Preferred Project Report Project Application

Albert Avenue and Thomas Street, Chatswood
Mixed Use Development (MP09_0066)

Submitted to
Department of Planning
On Behalf of Welles Thomas Pty Ltd

July 2010 ■ 09141

Figure 1 - Proposed zoning amendment

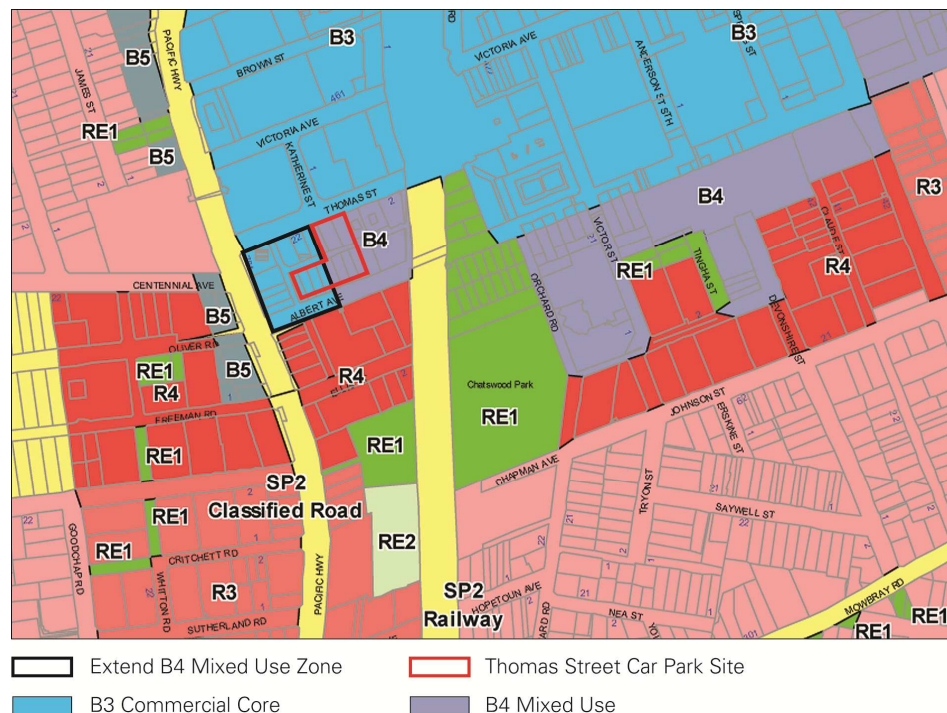
Although the proposed development will be permitted on the site under the proposed zoning controls, JBA, on behalf of Welles Thomas, has made a submission to Council recommending that a consistent Mixed Use zone be applied to the site as well as the broader block of land bound by Thomas Street to the north, the railway to the east, Albert Avenue to the south and the Pacific Highway to the west.

Implementing a split zone across a single development site is considered inappropriate and may result in adverse urban design outcomes. Furthermore, the development site and the broader area of land in which it is located provided a transitional zone between the Chatswood commercial core to the north (which is proposed to be zoned B3 Commercial Core) and the high density residential area to the south (which is proposed to be zoned R4 High Density) and is more appropriately zoned for mixed use purposes (see **Figure 1** below).
